CITY PLAN COMMISSION STAFF REPORT

Project Name
Mullins Corner

CD-CPC-2023-00105
Development Plan – Non-Residential

Project: MULLINS CORNER

BUILDING ELEVATIONS

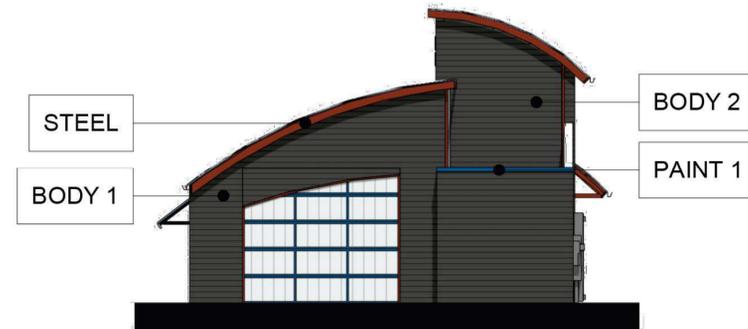
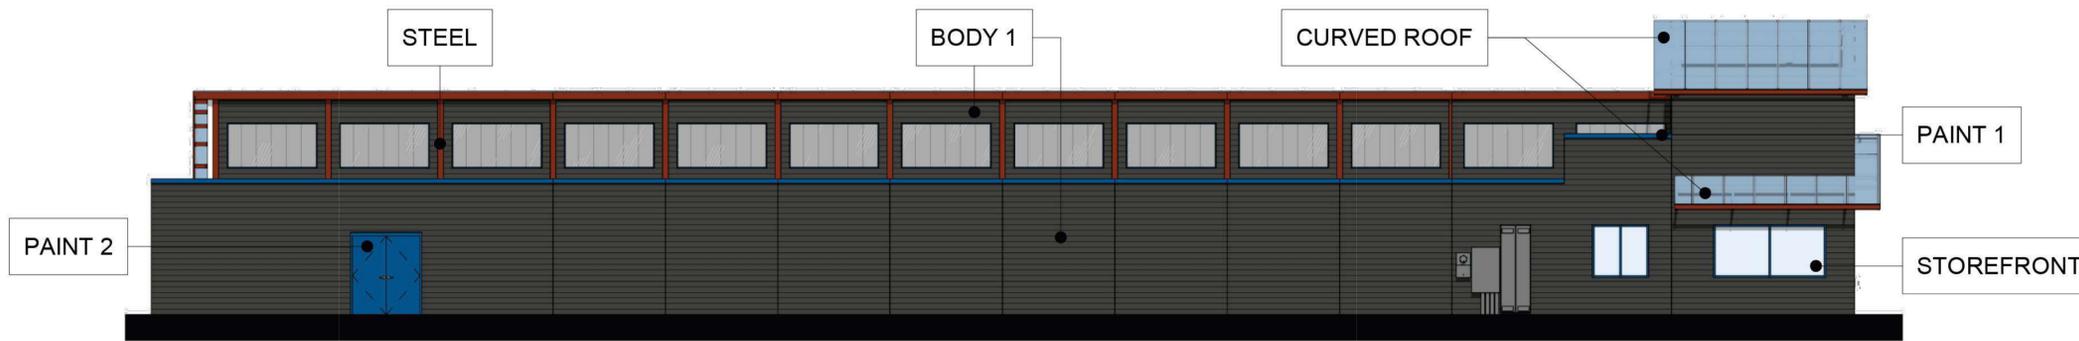
Proposed building materials for the carwash include stucco and metal panel for the majority of the building. The roof will be polycarbonate. Staff has added a condition for the applicant to continue working with the City to revise the proposed elevations prior to building permit to better reflect what is written in the design guidelines attached to this case. Landscaping for lot 4B will be reviewed at the time of building permit.

- F. The location, orientation, and architectural features, including design and material, of buildings and other structures on the site must be designed to be compatible with adjacent properties.**
The proposed design guidelines call out the use of building materials including brick, cast stone, stucco, and enhanced concrete panels that have the appearance of brick. One condition to this project dictates that the applicant continues to work with staff on the architectural design of the carwash building, as there is a large blank area on the rear façade.

10. The developer shall continue working with staff to revise building elevations for lots 4B to incorporate more of the high quality building materials listed in the design guidelines and label cardinal directions on front and rear facades prior to building permit.
